**AGENDA
PLANNING COMMISSION OF THE
CITY OF WHITE BEAR LAKE, MINNESOTA
MONDAY, NOVEMBER 28, 2022
7:00 P.M. IN THE CITY HALL COUNCIL CHAMBERS**

TO: The Planning Commission
FROM: Ashton Miller, City Planner
DATE: November 28, 2022
SUBJECT: **Smarte Carte Conditional Use Permit Amendment, 4455 White Bear Parkway, Case No. 93-3-Sa**

To: Ashton Miller, City Planner
From: Nathan Christensen, P.E., Assistant City Engineer
Connie Taillon P.E., Environmental Specialist/Water Resources Engineer
Date: November 10, 2022
Subject: **Smarte Carte Engineering Review Comments**

1 SITE DEMOLITION PLAN
D100 1" = 40'-0"

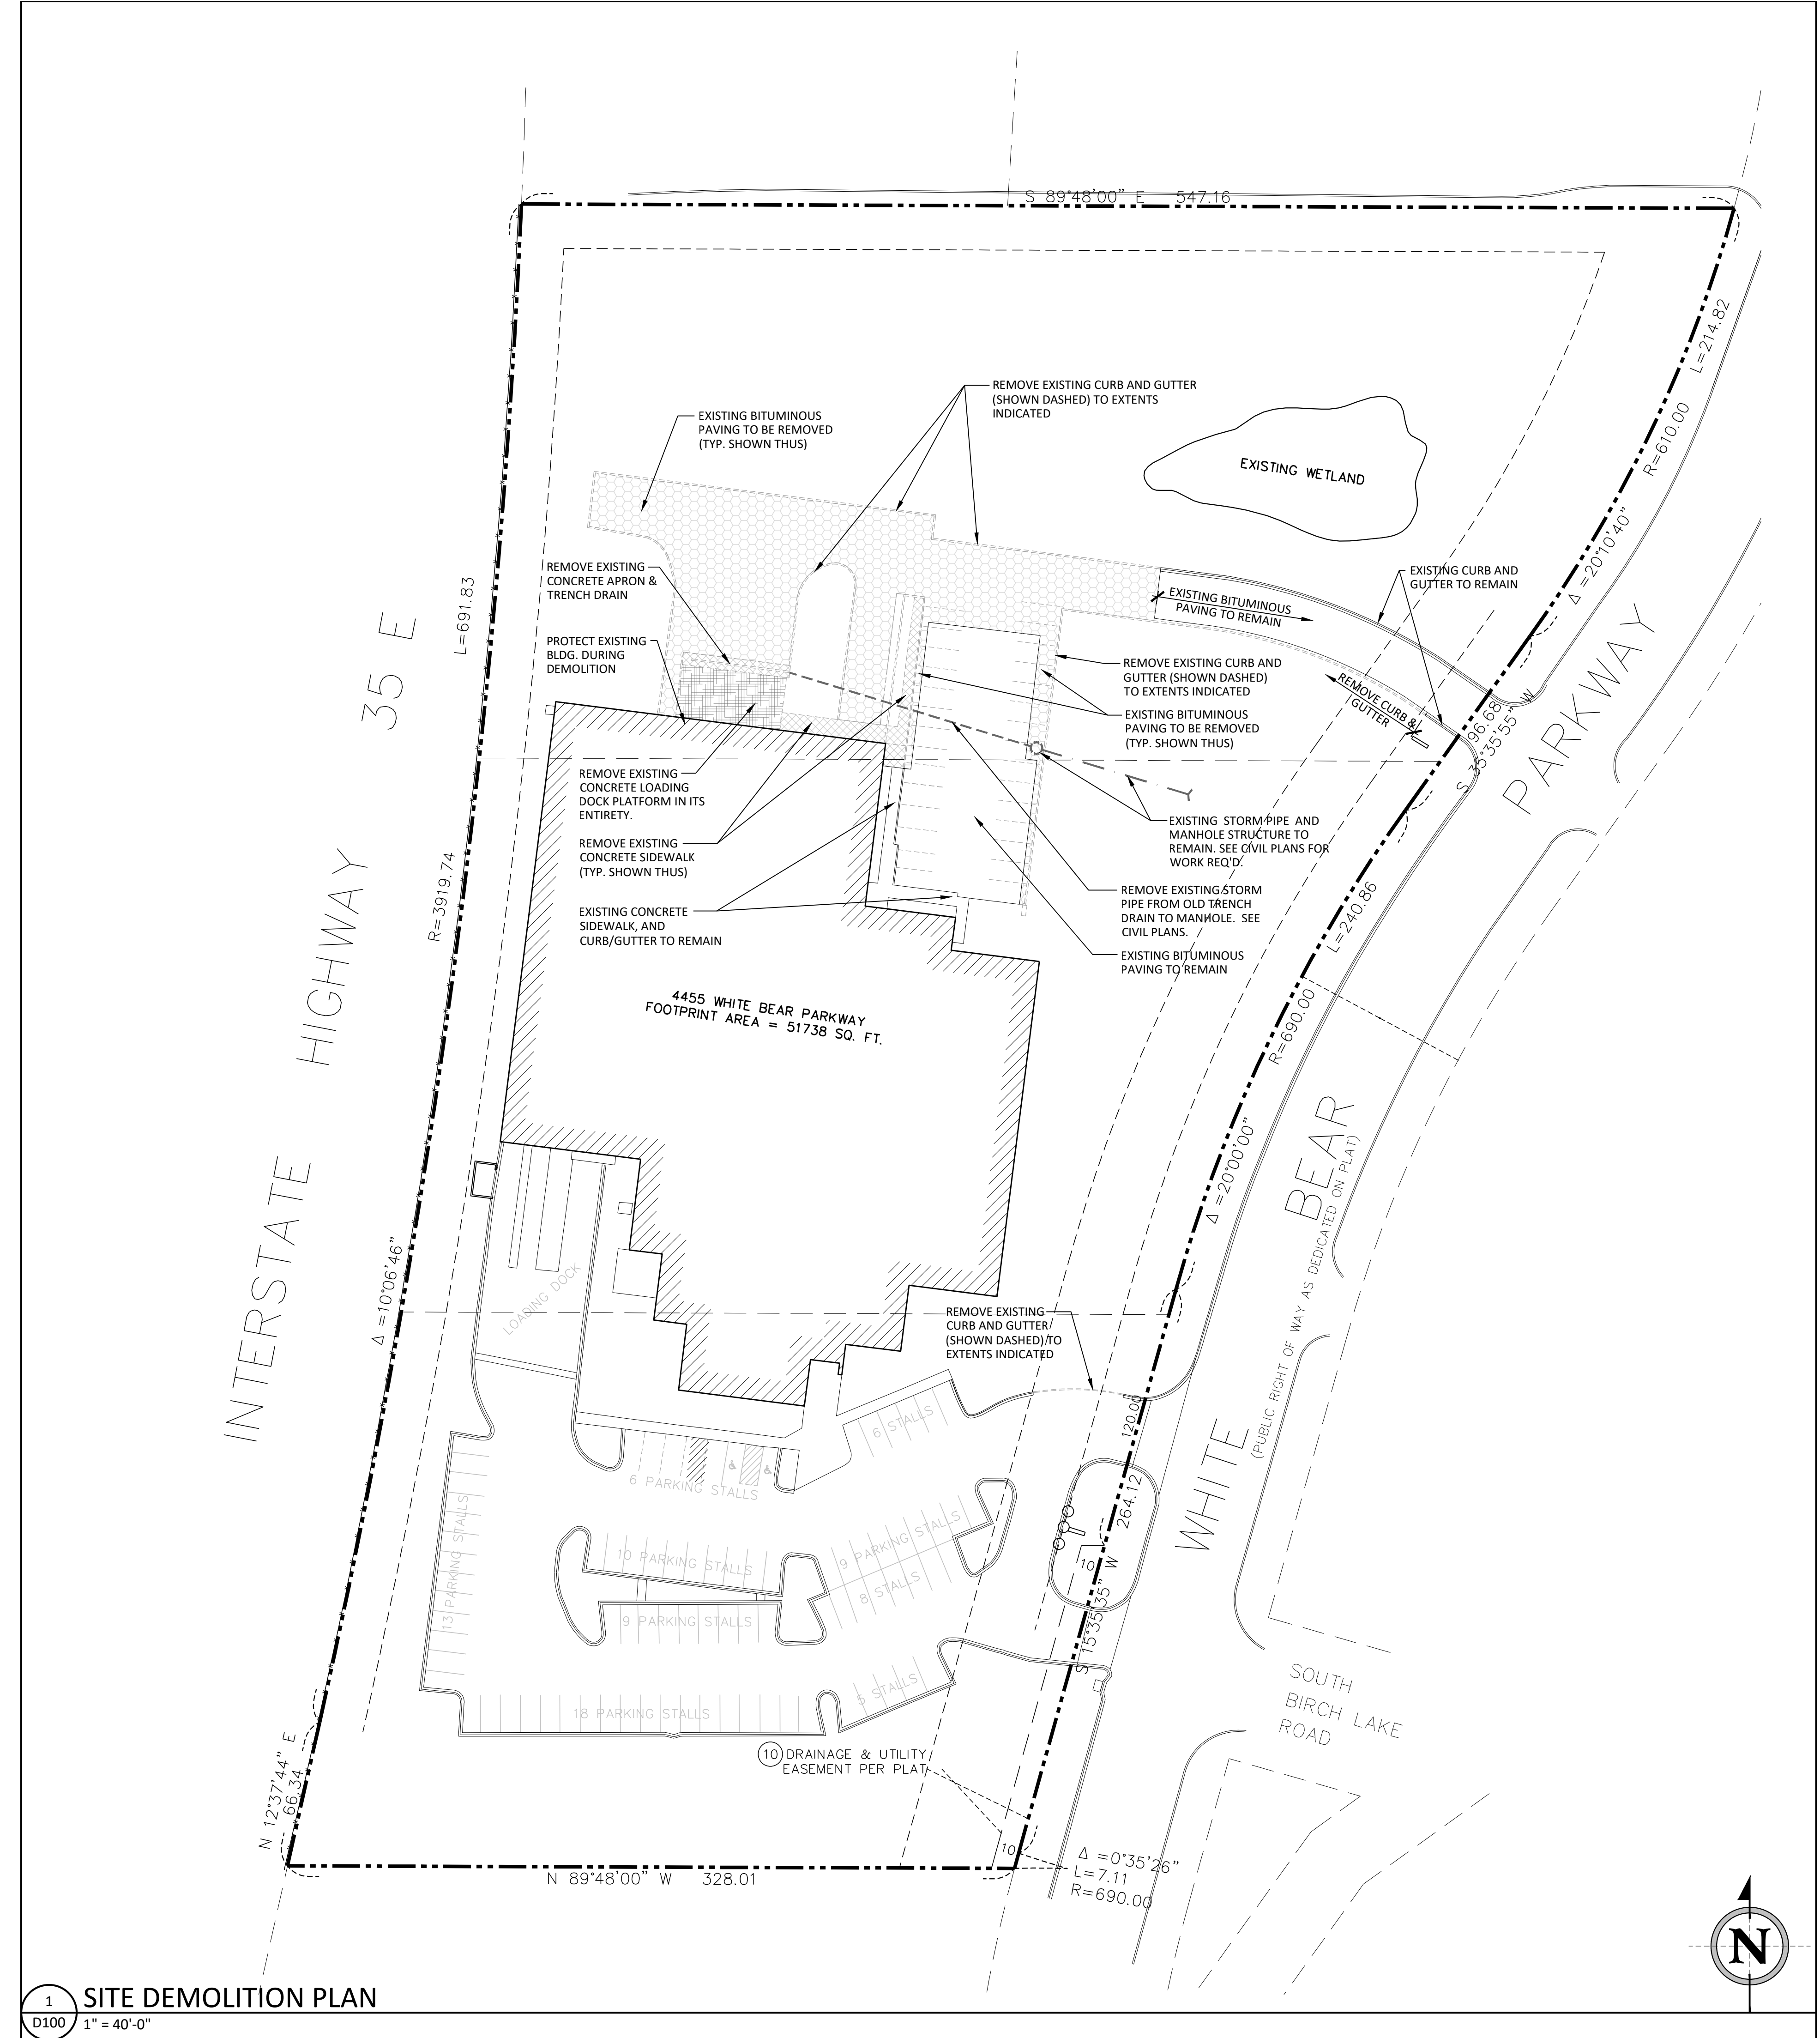
- 19) The limits of storm sewer pipe removal is not clear on the plan. Please clearly show the limits of storm sewer removal on the plan. Consider including the removals on the Site Demolition Plan or create a separate Utility Plan that shows existing, removals, and proposed utilities separate from the Grading Plan. See also comment 20.

10
C3
CONTROL STRUCTURE
NO SCALE

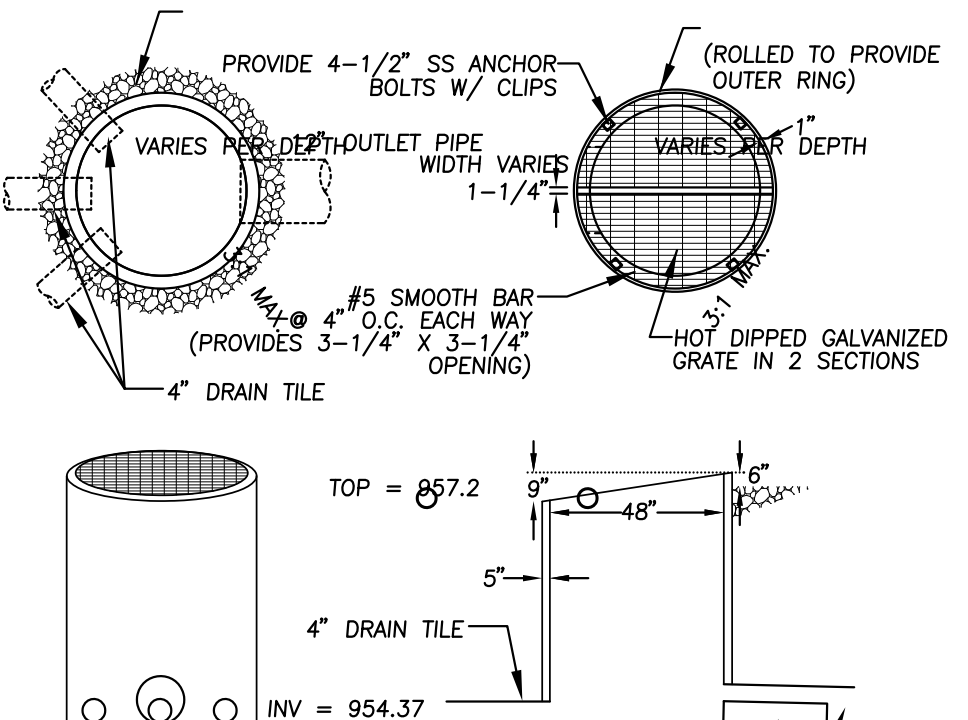
- 22) For detail 10 and 11, some of the details seem to be shifted. Please revise.
- 23) Outlet control structure (detail 10):
- a) Show the location of the grout on both the cross section and profile view of the outlet pipe, and label. The grout must fill the entire 12" pipe around the 6" pipe to function as modeled.

- b) Is the 12" outlet pipe existing? If so, label as existing. If proposed, then the Utility Plan will need to be revised.
 - c) Label the invert of the outlet pipe.

11
C3
BIOFILTRATION BASIN CROSS SECTION
NO SCALE

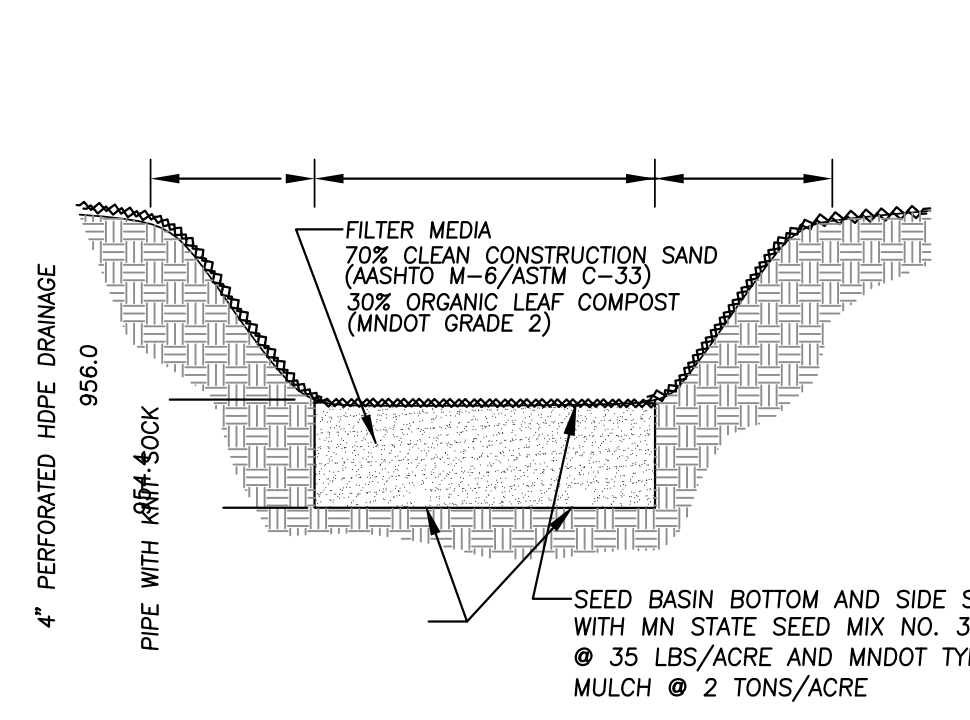
- 24) Biofiltration basin cross section (detail 11)
- a) Specify a native seed mix that prefers dryer conditions on the side slopes of the biofiltration basin above outlet elevation and show on the plan.

- b) Specify the type of temporary erosion control will be used in the basin while the plants are establishing.
- 25) Specify the type of seed and erosion control in the re-graded dry basin on the south end of the property.

LANDSCAPE PLAN NORTH:

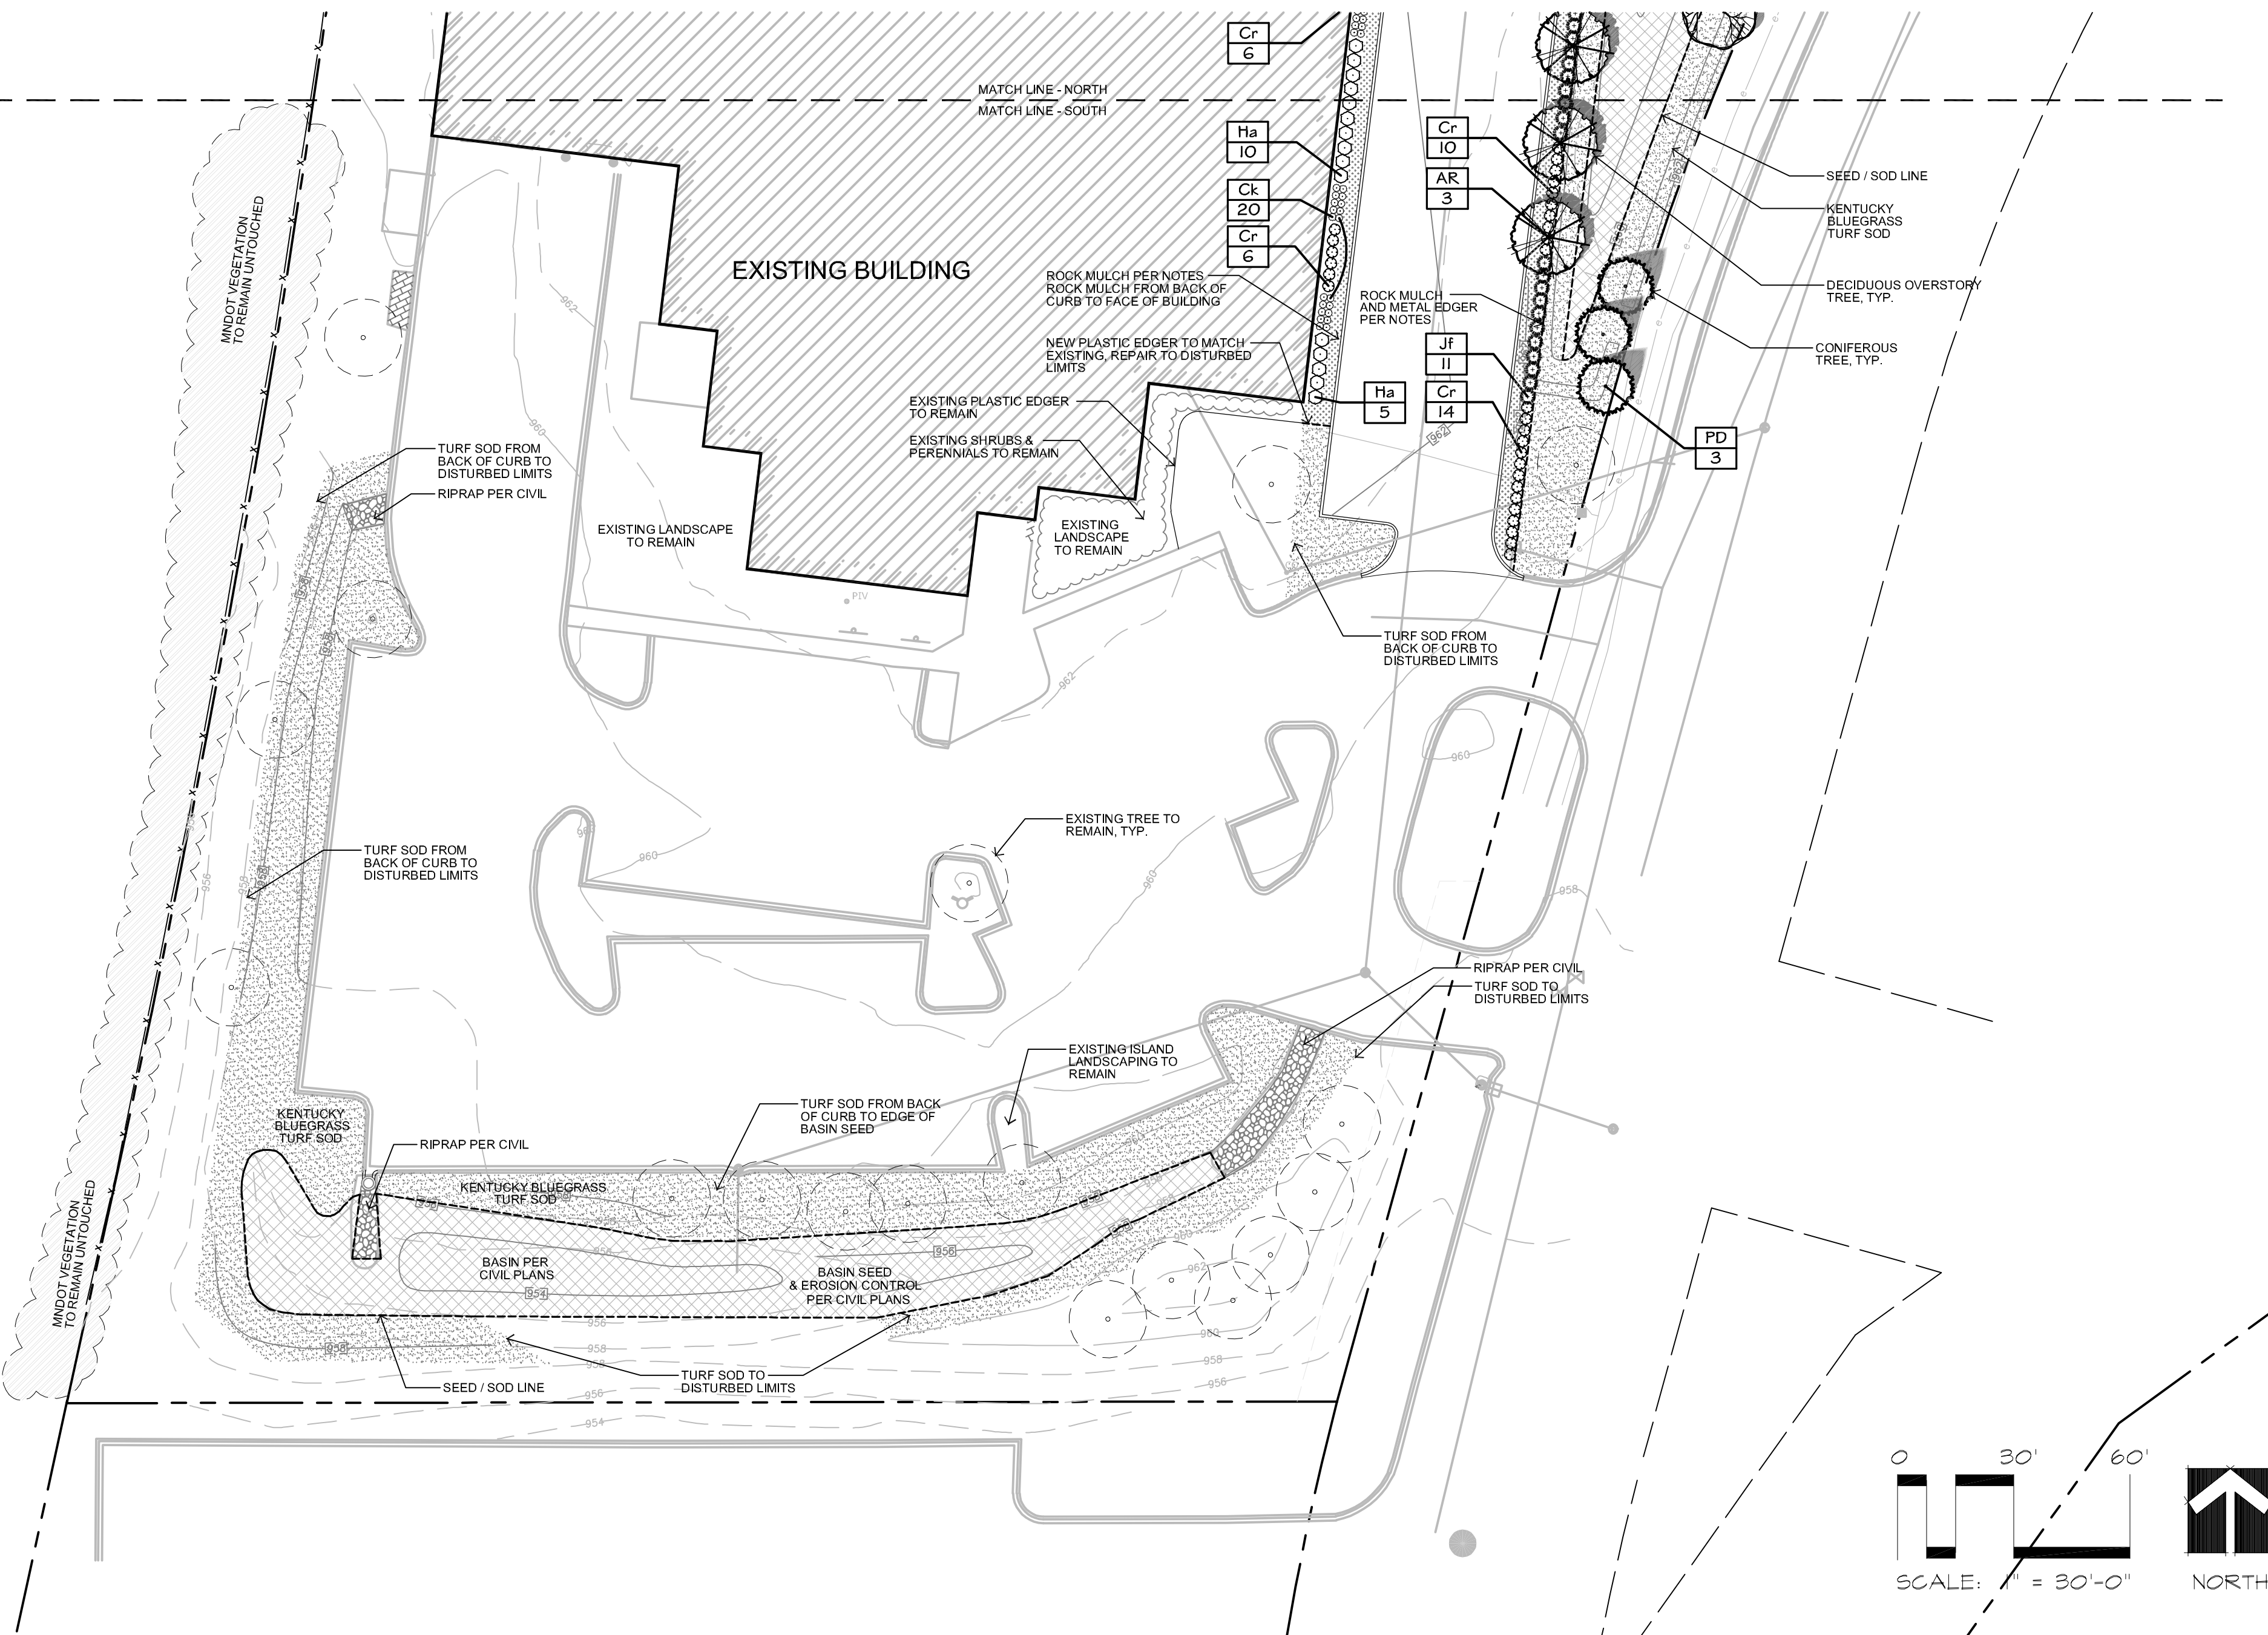
26) Portions of the wetland buffer that will be graded as part of this project or are currently planted with lawn grass shall be restored native vegetation. Please include this information on the plan.
